SERVICE LETTER

Service Letter No. L251
November 23, 2010

SUBJECT: Connecting Rod Bolt Marking

Figure 1. Variant Connecting Rod Bolt
Part Number Marking

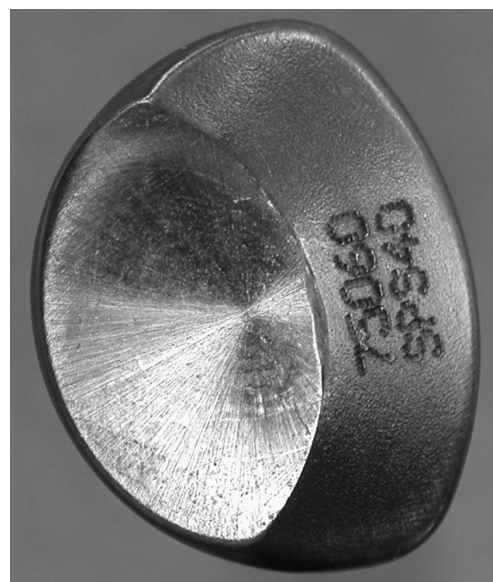
This Service Letter is a notice that recent lots of connecting rod bolts P/N 75060 have a variant marking of the part number on the bolt head as shown in Figure 1. Figure 2 shows the typical marking. **The bolt with the variant marking (in Figure 1) can still be used. It will not change measurements for stretch applications.** The part number marking in Figure 1 does not change form, fit or function.
